## Design Review Subcommittee (DRSC)

Meeting Date: July 29, 2015

**SUBJECT:** **Minor Architectural Permit 14-386, Pico Welcome Mural**, a request to consider a mural on the wall of a commercial center located at 415 West Avenida Pico, within the Community Commercial portion of the West Pico Corridor Specific Plan.

**Figure 1 – Proposed Location**

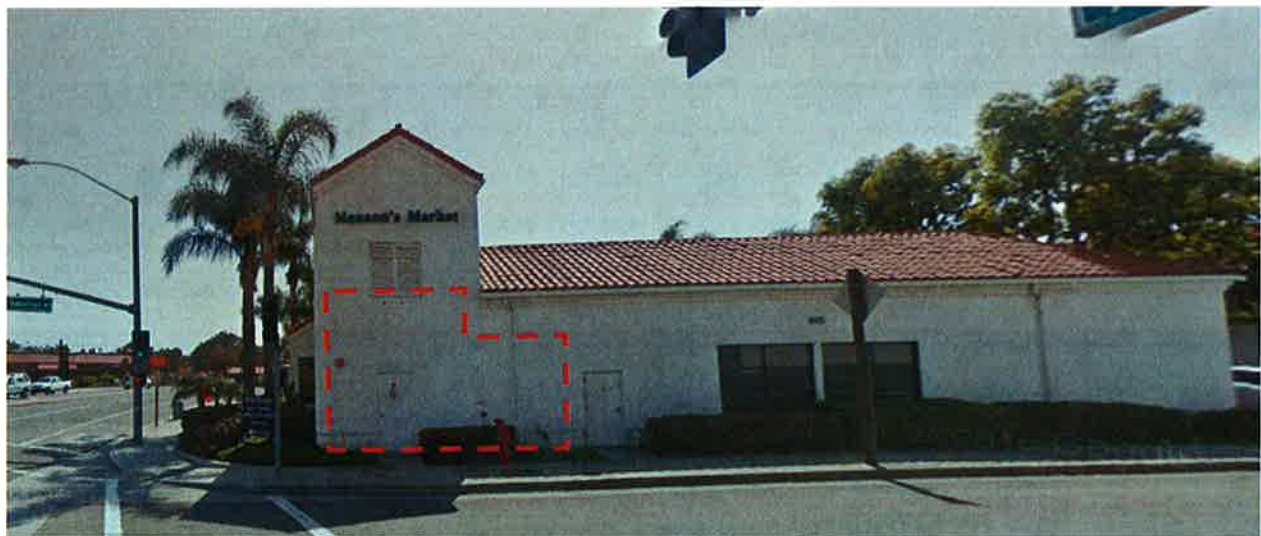
This project was reviewed by the Design Review Subcommittee (DRSC) on November 12, 2014. In their review, the DRSC was concerned with the size of the mural taking up the whole wall, lack of a frame and detracting from the design goals of the City Gateway area. The DRSC recommended design modifications to make the mural more compatible with the building and the vision for the surrounding gateway area.

The applicant proposes to paint a mural that is approximately 400 square foot on a street-facing wall located at the rear of the Hanson's Market building in the Pico Pavilion shopping center. The approximate area of the proposed mural is shown in Figure 1, below.

Illustration of Proposed Mural

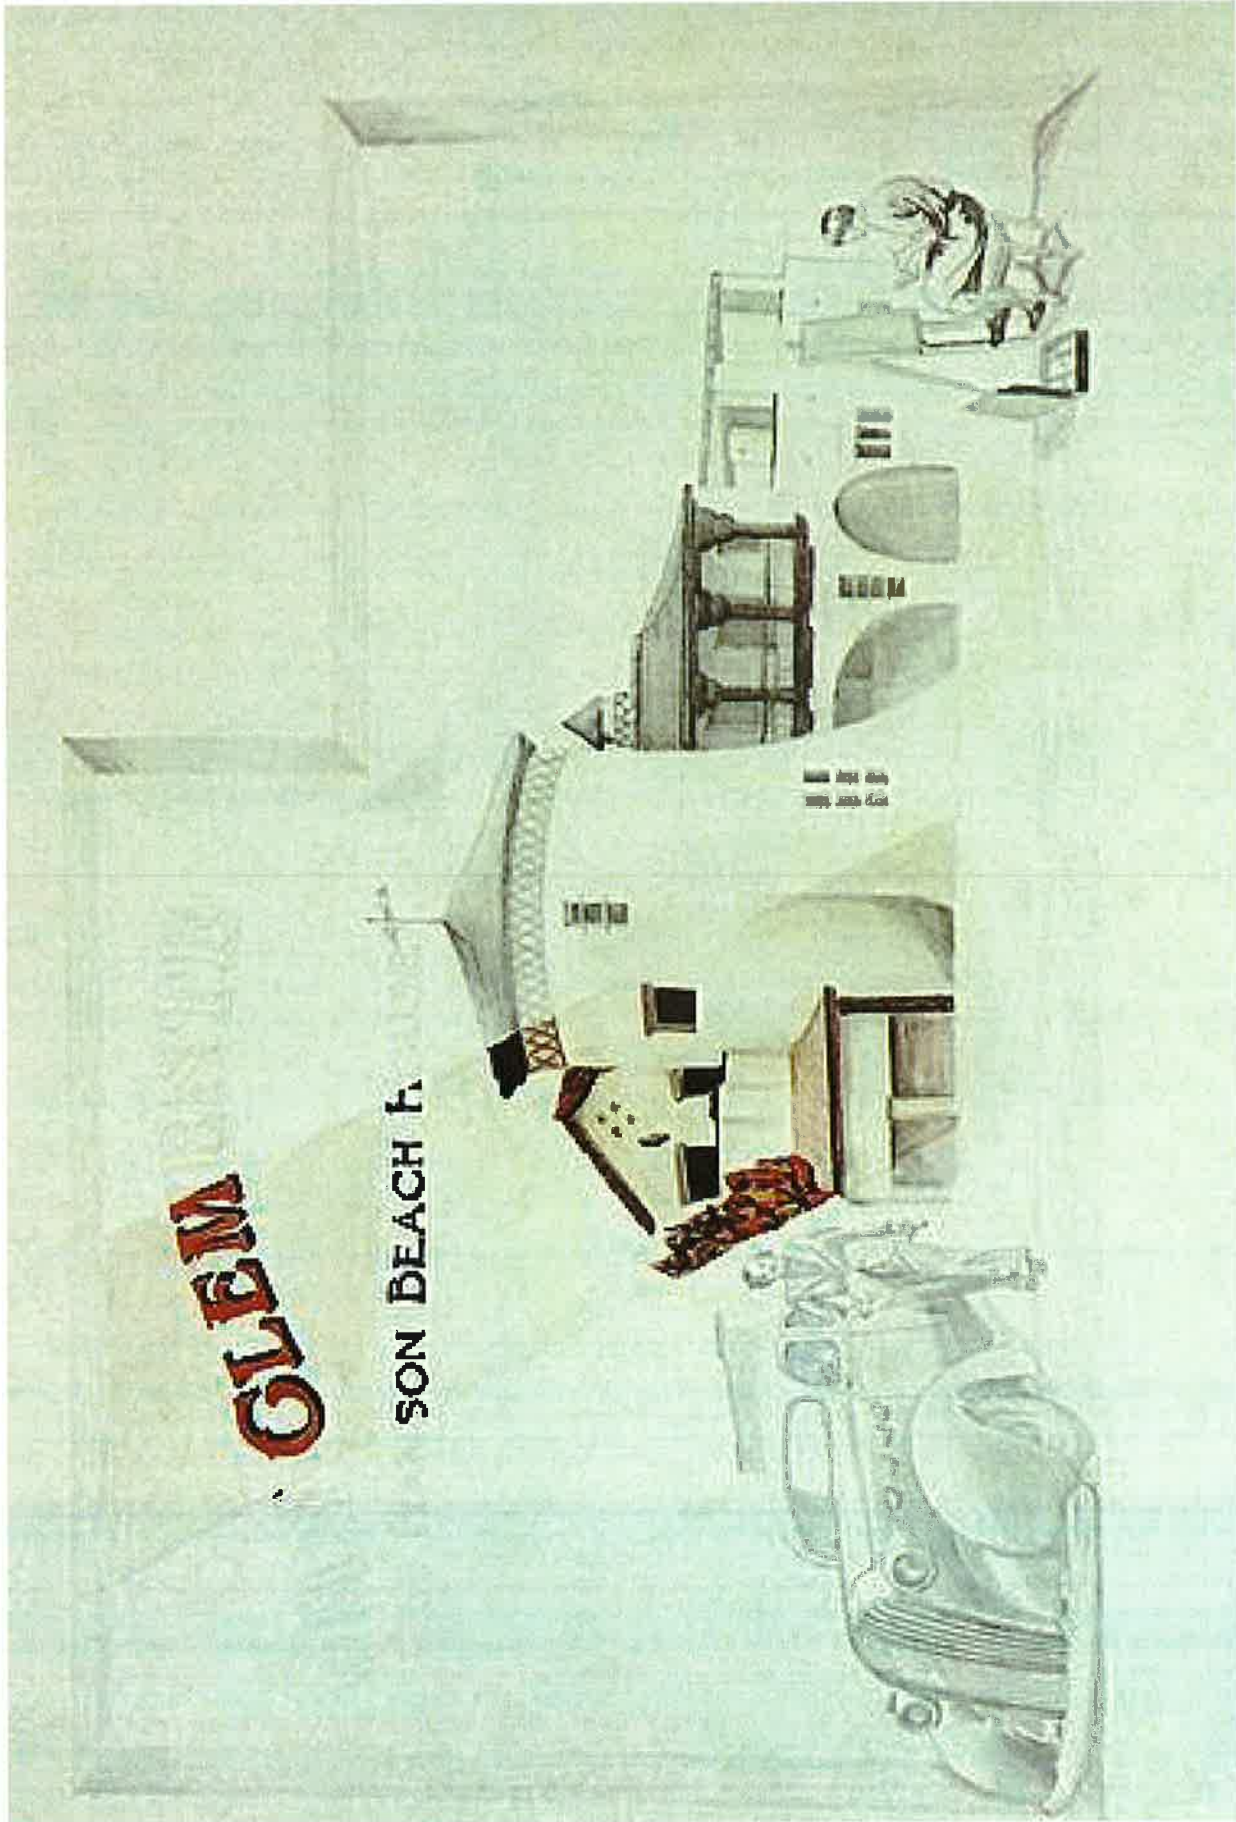
The proposed mural’s design quality is consistent with other approved murals, and the subject matter is compatible with the design goals of the General Plan and the WPCSP. Both of the other murals approved in the WPCSP area are of a more modest scale in terms of their coverage of the walls on which they are located, however, the generally muted tones of the proposed mural harmonize well with the Spanish-style design and white walls of the building. The reduced size of the mural greatly increases its compatibility with the building, serving to provide a unique design element on the structure rather than to overwhelm the entire façade. The simple frame provides a clean transition and sets this art work apart from the building, so as to not detract from the Spanish-style architecture.

Staff supports the proposed mural because of its sensitivity to, and enhancement of, the center’s Spanish architecture.
